City of Mississauga Department Comments

Date Finalized: 2021-11-02 File(s): A468.21

Property Address: 1459 Stavebank Road

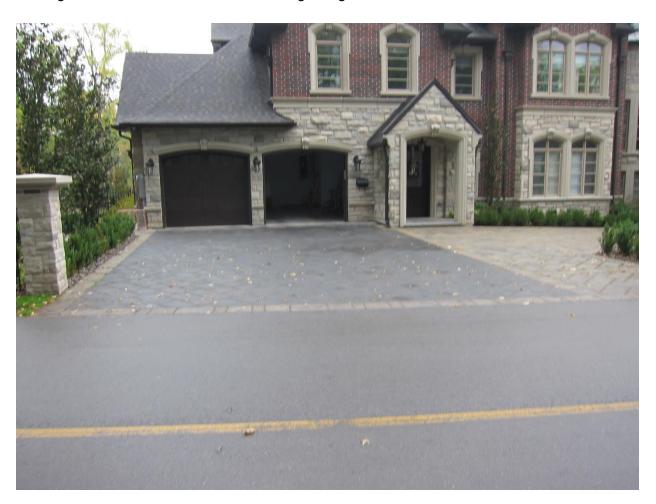
Enclosed for Committee's information are photos depicting the existing circular driveway. We advise that we have consulted with our Development Construction Section with regards to the drainage in this area and we do not have a grading concern with what has been built on site.
